Convoys Wharf, Deptford, SE10

2 February 2011

in the London Borough of Lewisham planning application no. DC/02/52533

Strategic planning application stage 1 referral 2000 Order

Figure 1: indicative site layout

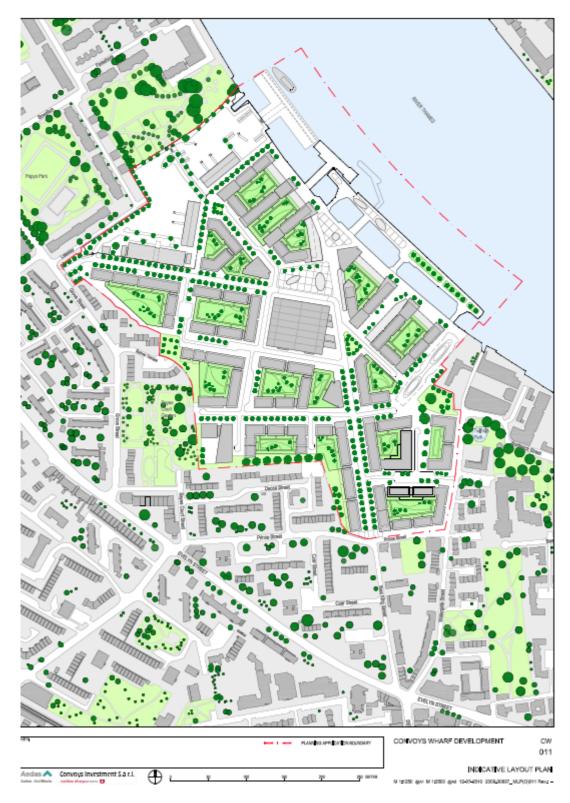
- Ideally the applicant would have submitted a masterplan as part of the outline application the submitted masterplan is stated as being indicative only. The Mayor does not consider it appropriate to grant planning permission at an outline stage for parameters which, if proposed in their full extent, at the detailed scale would be unlikely to be acceptable.

- Therefore the scale parameters and/or development parcels need to be more precise in terms of the building masses and scales to provide for a scheme which would generally be acceptable in all forms. It is not expected that this task will be overly burdensome as it seems clear that the applicants have a reasonably well developed masterplan which has been submitted for illustrative purposes only.

- Open space/Children's play space: there is an absence of any detail although the indication in the illustrative diagram would suggest that the proposal can make a valuable contribution to public space in this part of London.
